**SUNDRY NOTICES AND REPORTS ON WELLS CONSERVATION**  
Do not use this form for proposals to drill or re-enter an abandoned well. Use form 3160-3 (APD) for such proposals.

8. Well Name and No.  
COTTONWOOD DRAW 22 FEDERAL 2

9. API Well No.  
30-015-36757-00-S1

**\*\* BLM REVISED \*\* BLM REVISED \*\* BLM REVISED \*\* BLM REVISED \*\* BLM REVISED \*\***

Cottonwood Draw 22 Federal #2

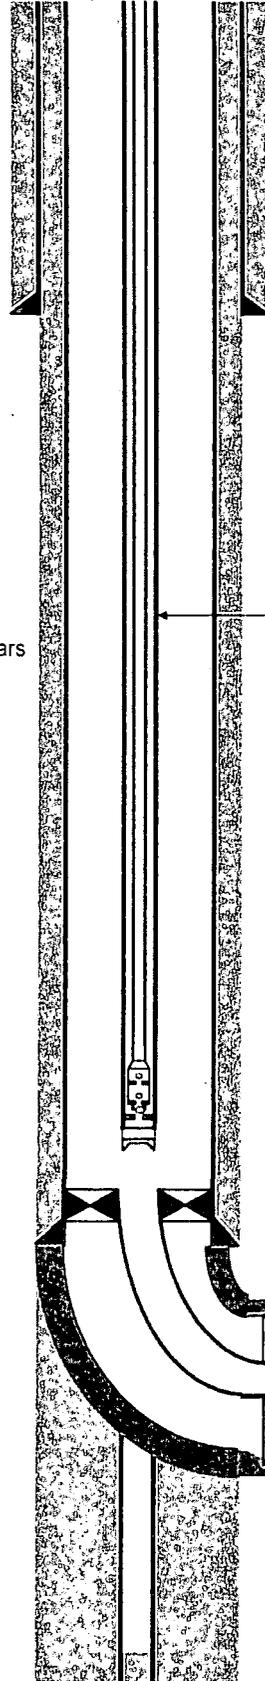
8-5/8", 24# J-55 csg @ 420', cmtd w/ 350 sx, cmt circ. ✓

TOL @ 2655' ✓

cmtd w/ 1075 sx, cmt circ ✓

Liner: 2-7/8" 6.5# L-80 @ 4705' ✓
